CITY OF PORTLAND, MAINE

HISTORIC PRESERVATION BOARD

HISTORIC PRESERVATION BOARD MEETING

- i. Preliminary Review of Revised Design Proposal for New Construction, 76 Congress Street (site of former St. Lawrence Church sanctuary); Friends of the St. Lawrence Church, Applicant.
- ii. Preliminary Review of Proposed Alterations, 9 Bowdoin Street; Barbara and Robert Burgess, Applicants.

SITTING WALL / PERGOLA SECTION
1/2" = 1'-0"

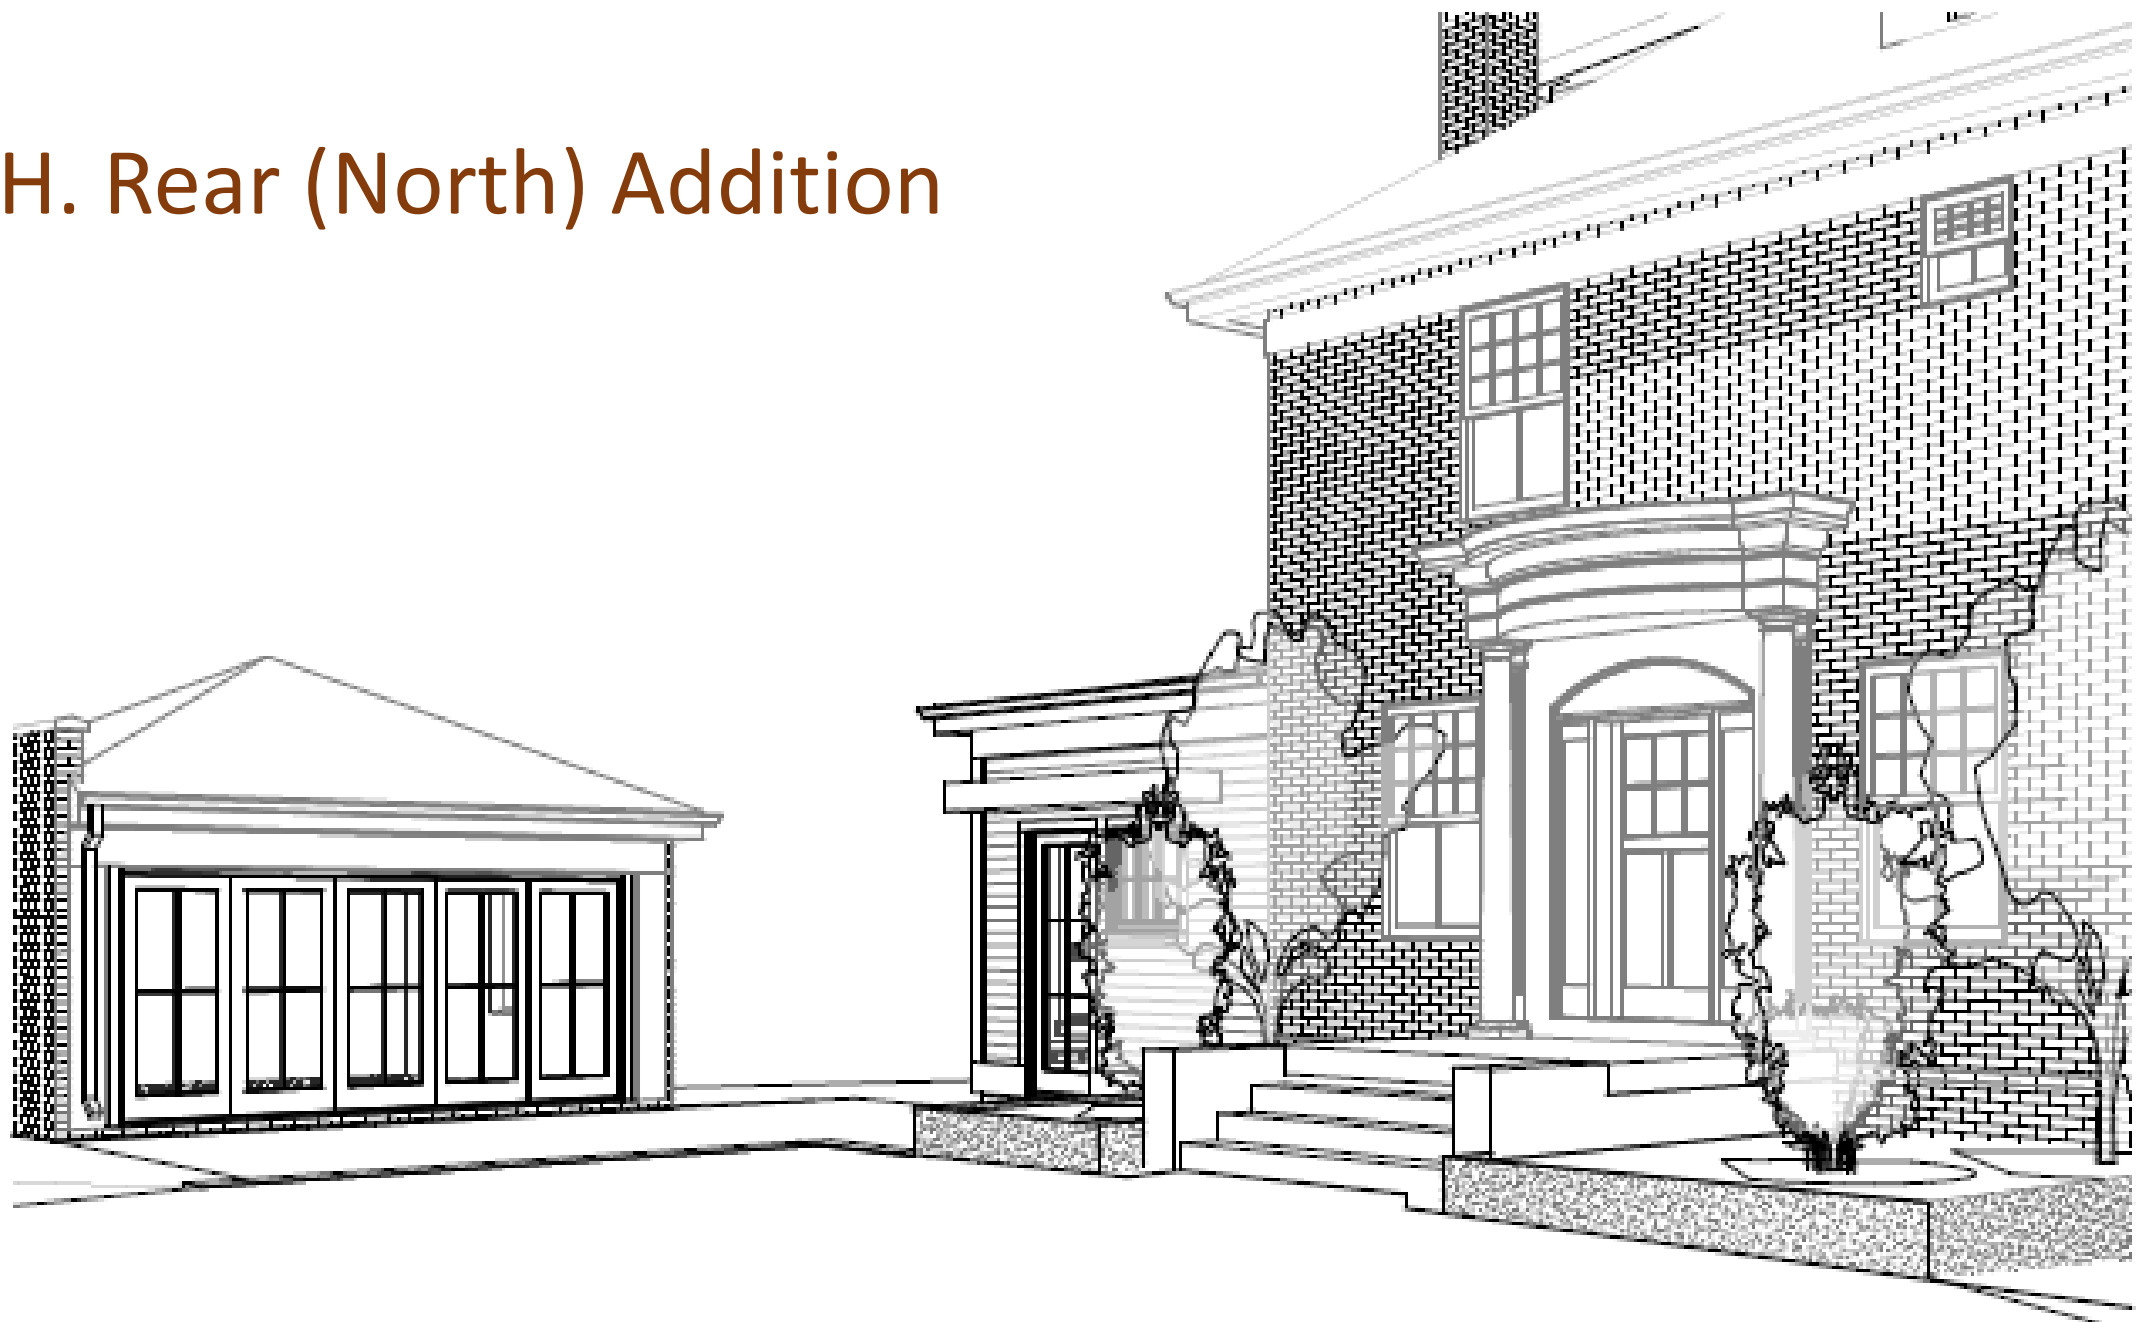
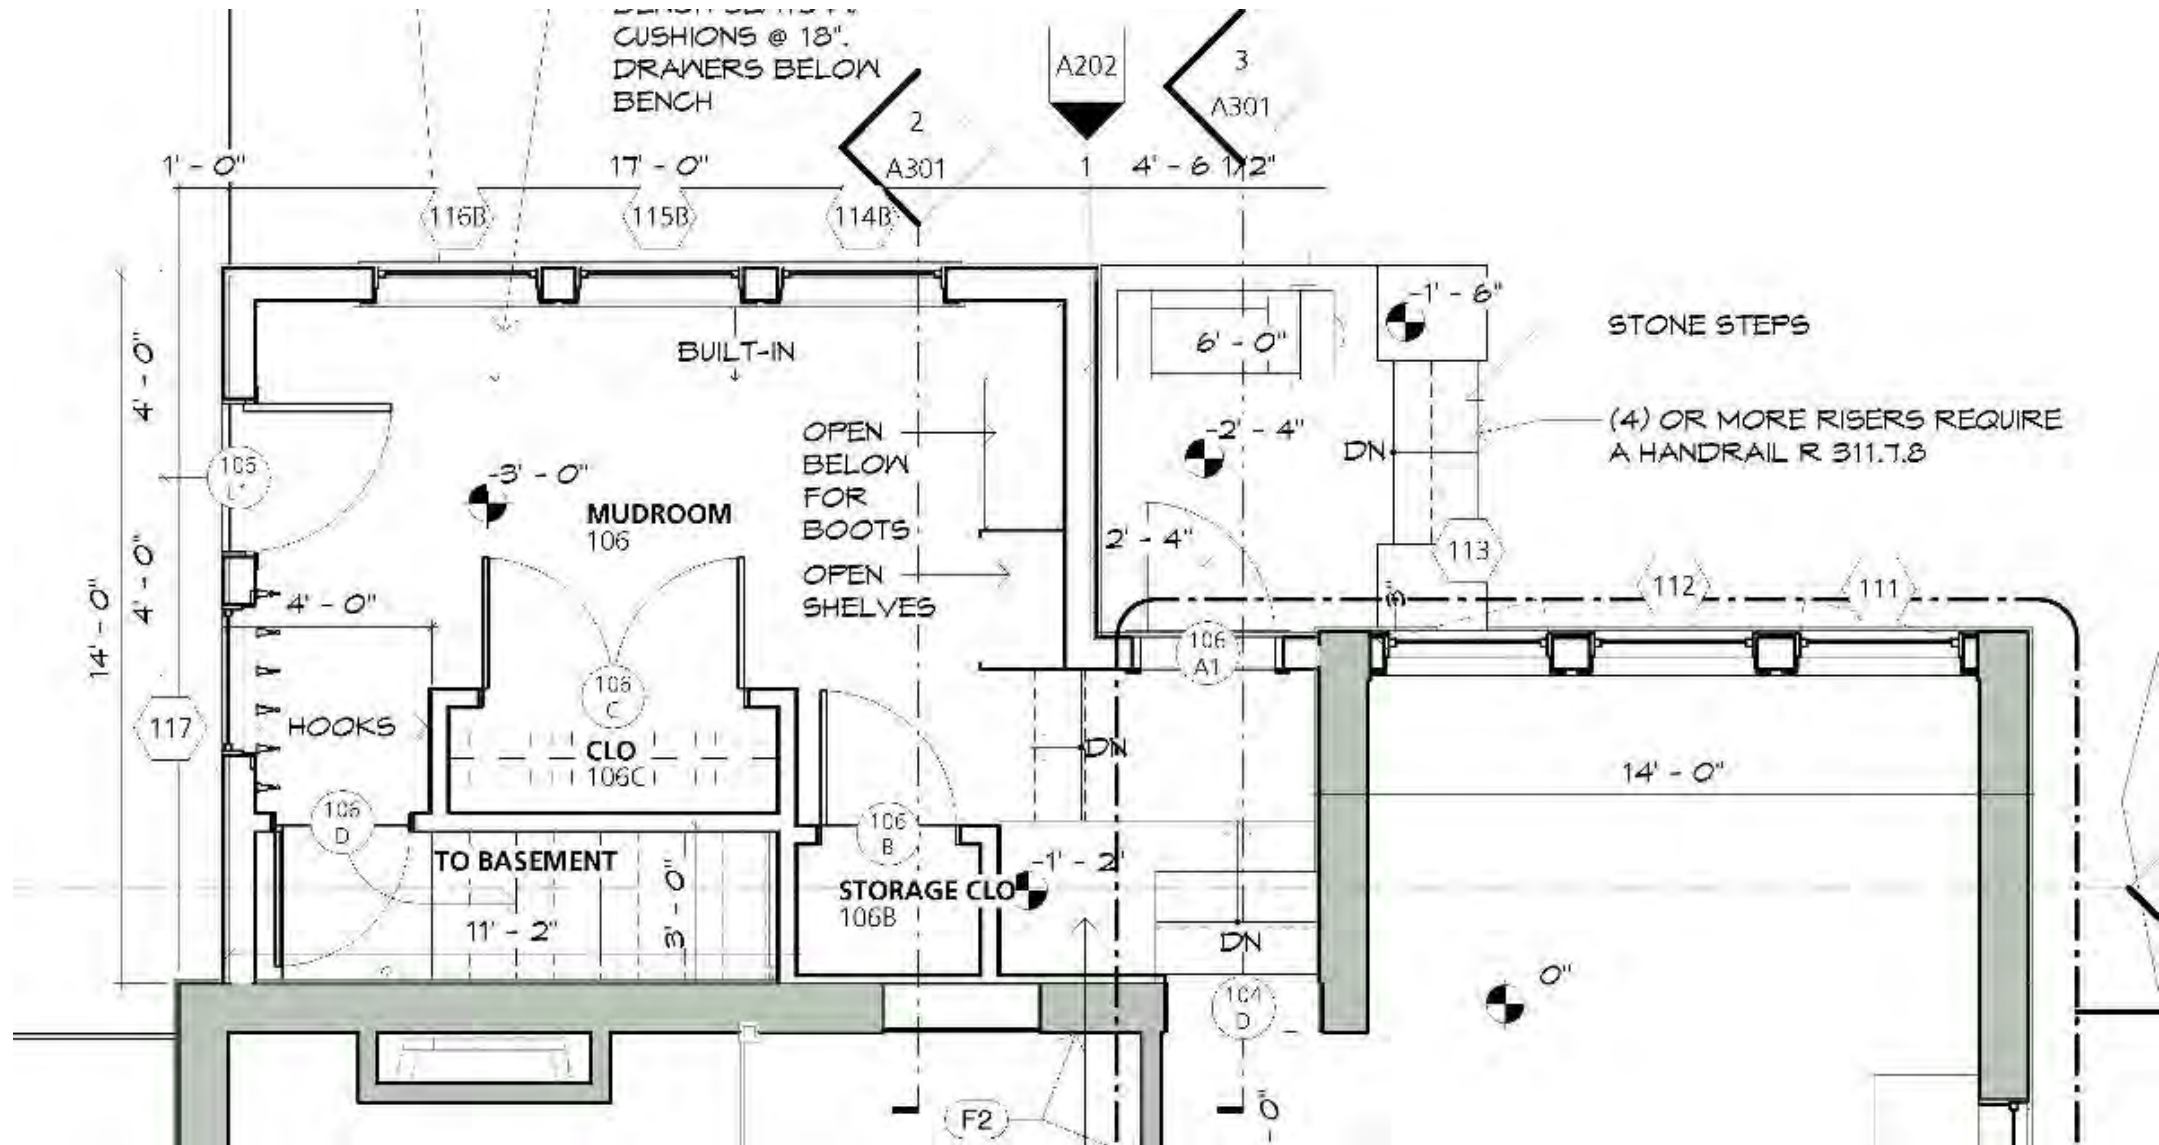
To the side and just forward of the garage, the proposed site plan includes a paved patio with a pergola shading it. Four 6” Corten tube steel posts would support a superstructure of natural wood. Like the folly, this additional structure in the yard would be quite far back from the street. Though staff might discourage adding an excessive number of features to the grounds that would interfere with the house, the existing yard is quite open. The owners have quite a bit of latitude in how they will use it, and are under no obligation to keep it empty. A pergola would be fairly easy to make reversible, and in the proposed location it would not interfere with views of the primary focus of the property, the house.
